Access Compliance Report

Public Rights-of-Way

Intersection ID: 42785	Main Street: CALDWELL_RD	Cross Street: OLD_STONE_CROSSING_DR	Location: S
ADA ID: D6513C03C207	Ramp Type: Combination1	Initial Pass/Fail: Fail	Overall Compliance: No
			Severity Score: 58.75

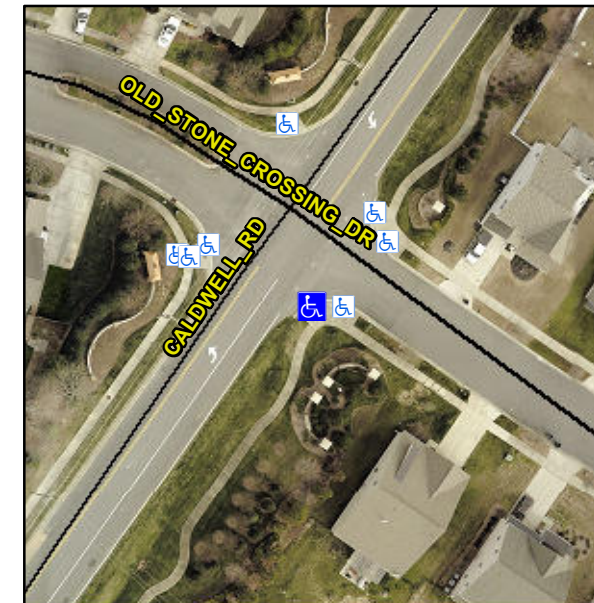
Not Found, R304.5.1, R304.5.3, R304.3.2

Compliance	Description	Data	Compliance	Description	Data
N/A	Ramp Length LT (in)	9.0	N/A	Ramp Length RT (in)	29.0
Yes	Ramp Width LT (in)	60.0	Yes	Ramp Width RT (in)	59.5
Yes	Ramp Slope LT (%)	6.8	No	Ramp Slope RT (%)	12.6
Yes	Ramp XSlope LT (%)	0.9	Yes	Ramp XSlope RT (%)	1.3
N/A	Ramp Length (in)	71.5	Yes	Ramp Slope (%)	0.2
No	Ramp Width (in)	47.0	No	Ramp XSlope (%)	9.0
N/A	Flare Type LT	N/A	N/A	Flare Type RT	N/A
N/A	Flare Slope LT (%)	N/A	N/A	Flare Slope RT (%)	N/A
N/A	Flare Traversable LT?	N/A	N/A	Flare Traversable RT?	N/A
N/A	Landing Length (in)	N/A	N/A	DWS Provided?	N/A
N/A	Landing Width (in)	N/A	N/A	DWS Contrast?	N/A
N/A	Landing Slope (%)	N/A	N/A	DWS Length (in)	N/A
N/A	Landing X Slope (%)	N/A	N/A	DWS Full Width?	N/A
N/A	Landing Curb? (Y/N)	N/A	N/A	DWS Offset (in)	N/A
N/A	Shared Landing?	N/A			
N/A	Gutter Ponding?	N/A	N/A	Gutter Slope (%)	N/A
N/A	Gutter Lip Ht (in)	N/A	N/A	Gutter X Slope (%)	N/A
N/A	Painted X Walk1?	No	N/A	Painted X Walk2?	N/A

Remove & Replace Entire Ramp.
